City of Sugar Hill Planning Staff Report CBD Design Review 24-004

SUBJECT: Central Business District (CBD) Design Review

5423 Nelson Brogdon Blvd., New Medical Office

DESIGN REVIEW CONCEPT PLAN

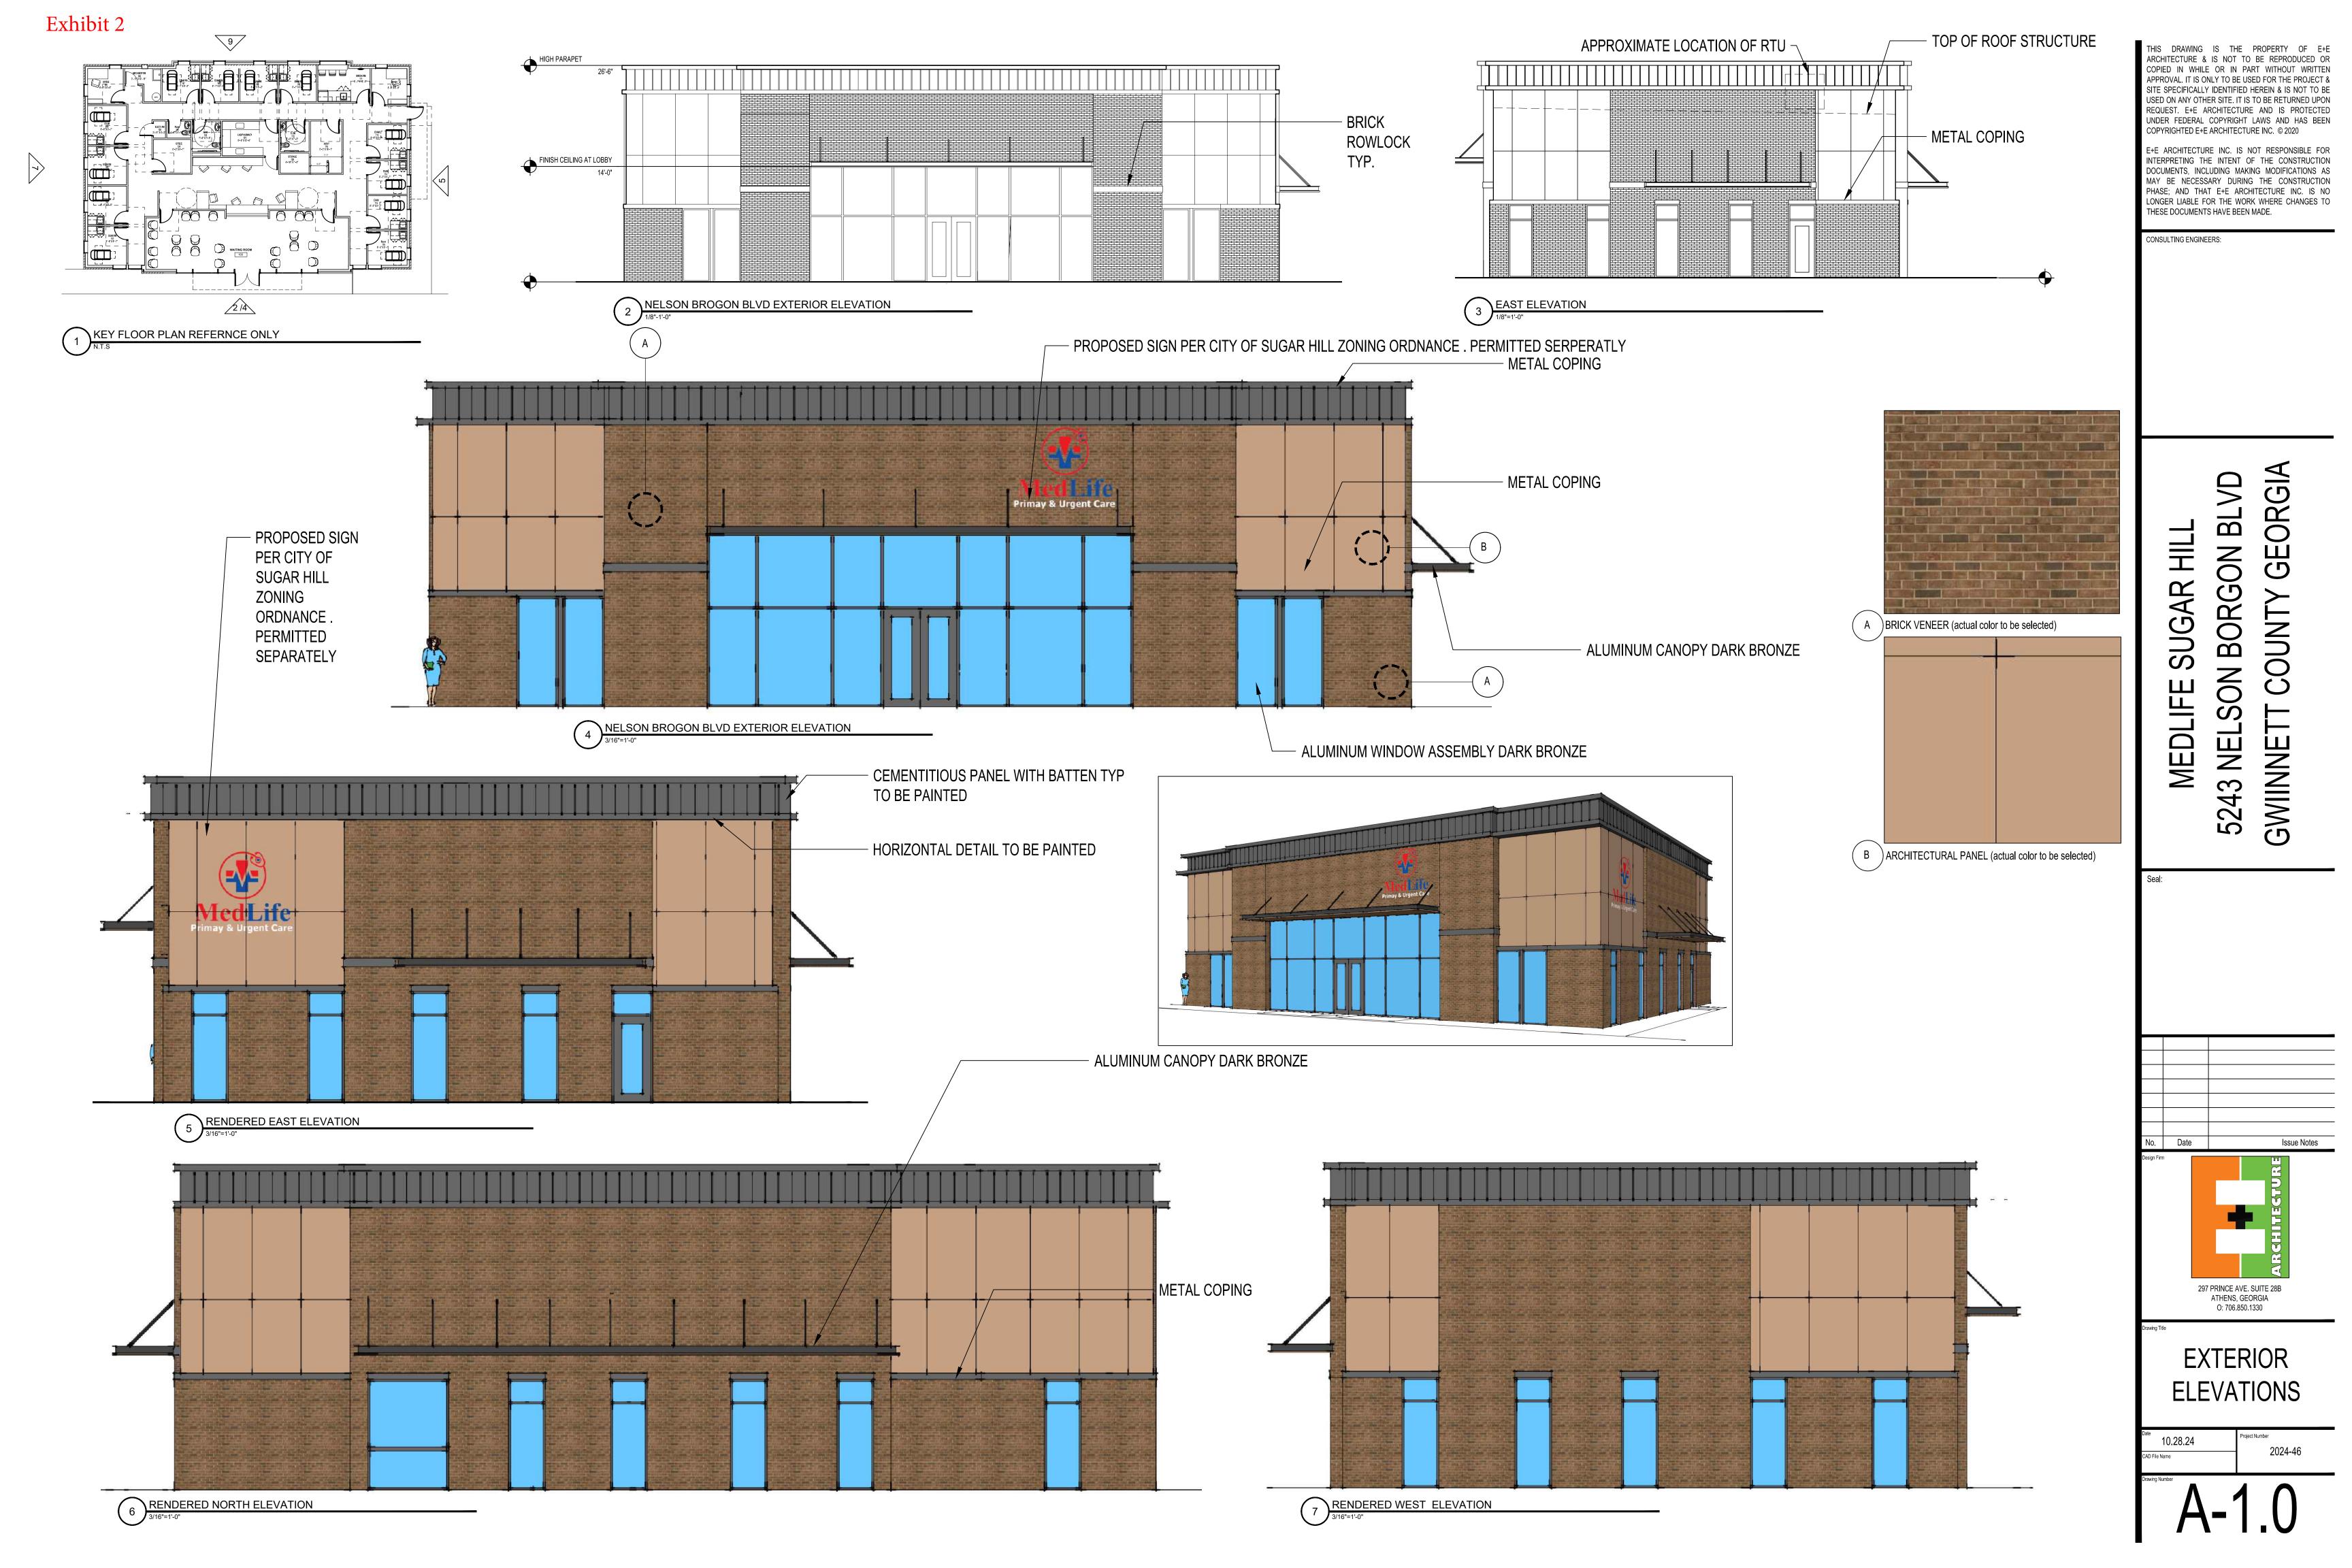
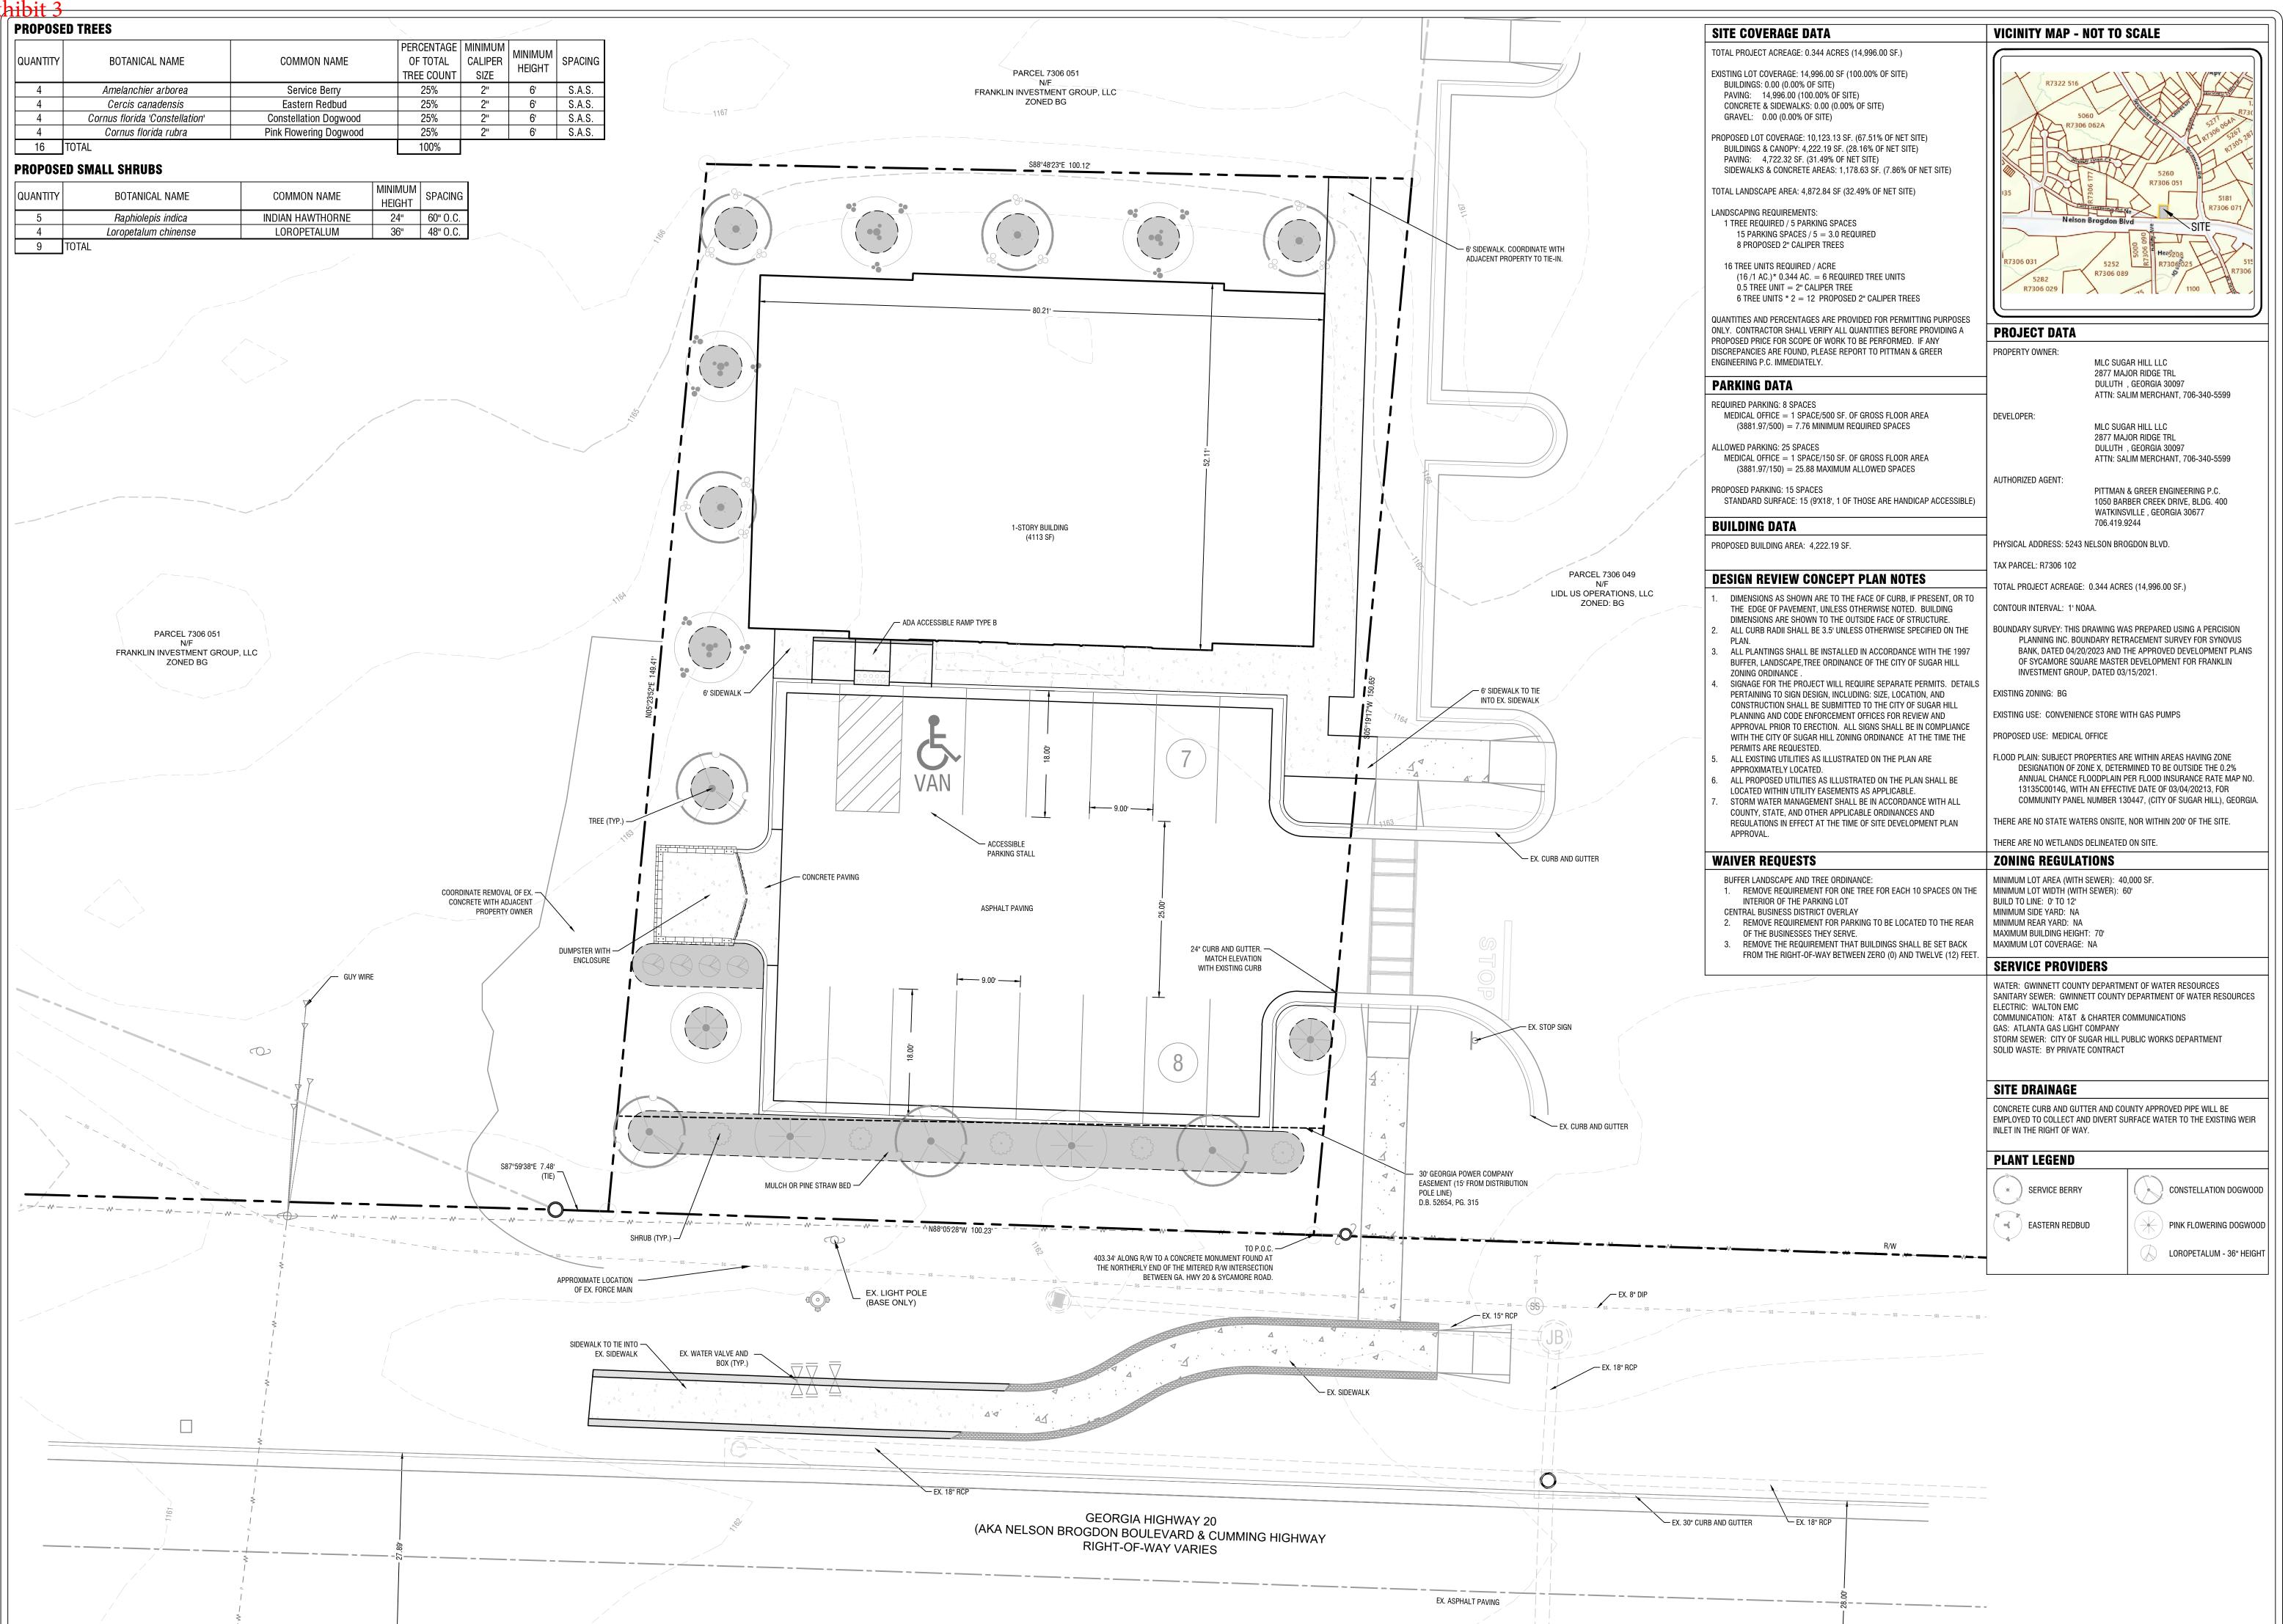
- The applicant has submitted two options for site layouts. Exhibit 1, which is preferred by staff, locates the building along Nelson Brogdon, with parking at the rear of the property. This layout most aligns with the spirit and intent of the CBD regulations and design of the adjacent master development. This layout will require coordination with the adjacent property owner in order to provide interparcel access.

- o Remove Requirement for One Tree for Each 10 Spaces on the interior of the parking lot (BLT 4.3.1.B). The applicant has expressed inability to accommodate the anticipated parking needs of the proposed use while providing the required tree units. The applicant has proposed exploring alternative landscaping alternatives.

- o Remove requirement that buildings shall be set back from the right of way between 0 and 12 feet (ZO Section 1002 E.1.III). An existing power easement extends 15' into the property; therefore, preventing the building to be located between 0'-12' off of the right-of-way as required by the Zoning Ordinance. Exhibit 1 located the building toward the front of the property with the building setback off of the proposed landscape strip adjacent to the power easement. Exhibit 3 locates the building towards the rear of the property. This would require a significant departure from the 0' to 12' building setback provided for the CBD with the building being setback at least 75' from the right-of-way.

- 1. Final building design and site layout shall substantially resemble the attached exhibits labeled Exhibit 1 through 2. Final material and color selections shall be subject to on-site mock-up approval, with identified materials. Alterations to the façade in order to conform to the conditions listed below are subject to review and approval by the Planning Director.

- 2. The building setback line shall be between 0' and 12' off of the utility easement along Highway 20.
- 3. In lieu of the requirement for 1 tree per 10 parking spaces, landscape strips shall be present along the perimeter of the property and shall conform to the standards set forth in the Buffer, Landscape, and Tree Ordinance, subject to the review and approval of the Planning Director.
